# **Geotechnical Investigation**

## **Proposed Industrial Redevelopment**

135 Cardevco Road  
Carp, Ontario

Report PG6018 -1 Revision 7 dated March 24, 2025

Figure 2 - Retaining Wall Cross Section Location

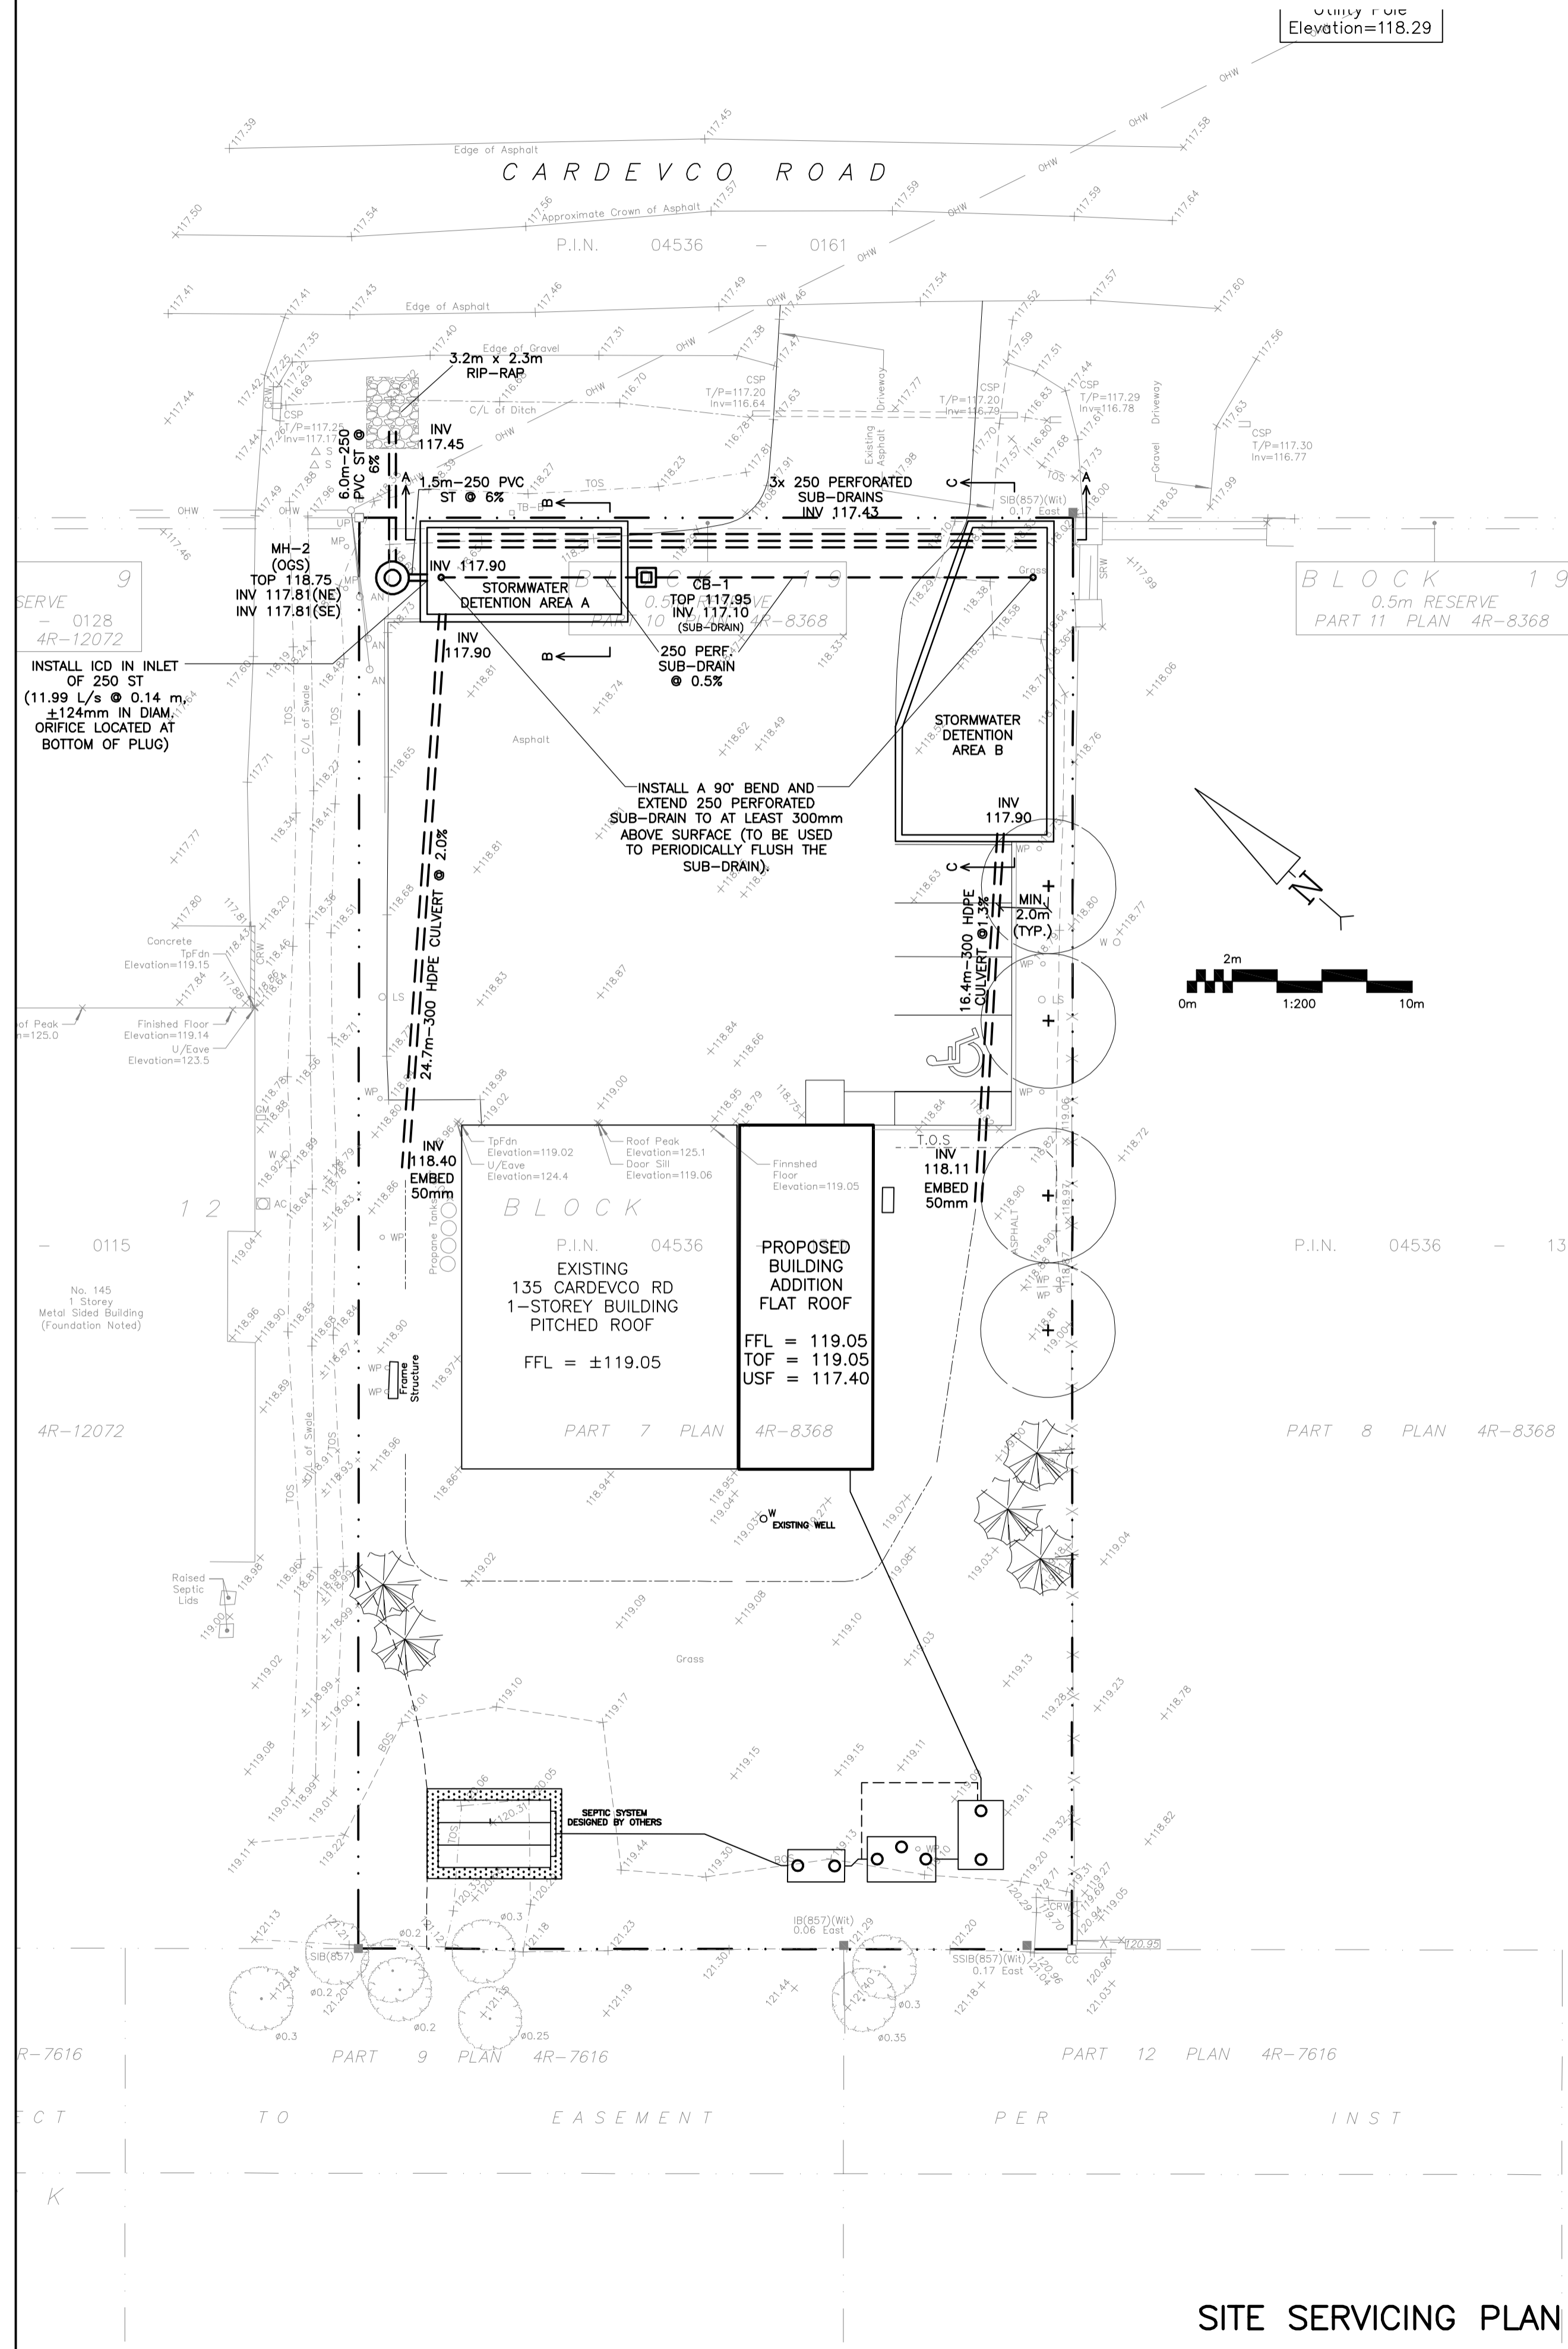
**Comment 8.b:** *The Geotechnical report prepared by Paterson Group Inc., dated November 24, 2023; Revision 4, requires a 1H:1V slope from the ground surface to the bottom of the retaining wall or a minimum of 1m setback from the back of the wall, for a proper placement and compaction of the backfill material.*

*This requirement appears not to have been met for either of the two infiltration trenches. Please provide dimensions between the SWM features and the adjacent property lines on the Servicing & Grading Plan to confirm the required backfill set-back design requirements. Please also coordinate with the Arbaum architects who prepared the Stormwater Detention retaining Wall Details Plan (S300), which shows the distance to the property line, as 1 foot and 0 inches.*

**Comment 10.b:** *Cross-Sections show setback behind the retaining walls between 0.15 m – 0.35 m. Please see the comments above pertaining to the minimum backfill requirement and impacts to the adjacent properties.*

**Response:** This comment has been acknowledged. Please refer to the updated geotechnical report mentioned above. Alternative backfill materials have been proposed in cases where there is a limited setback between the proposed retaining wall and the property line.

**Response:** Reference should be made to our response to Comment 8.b in the current memorandum.
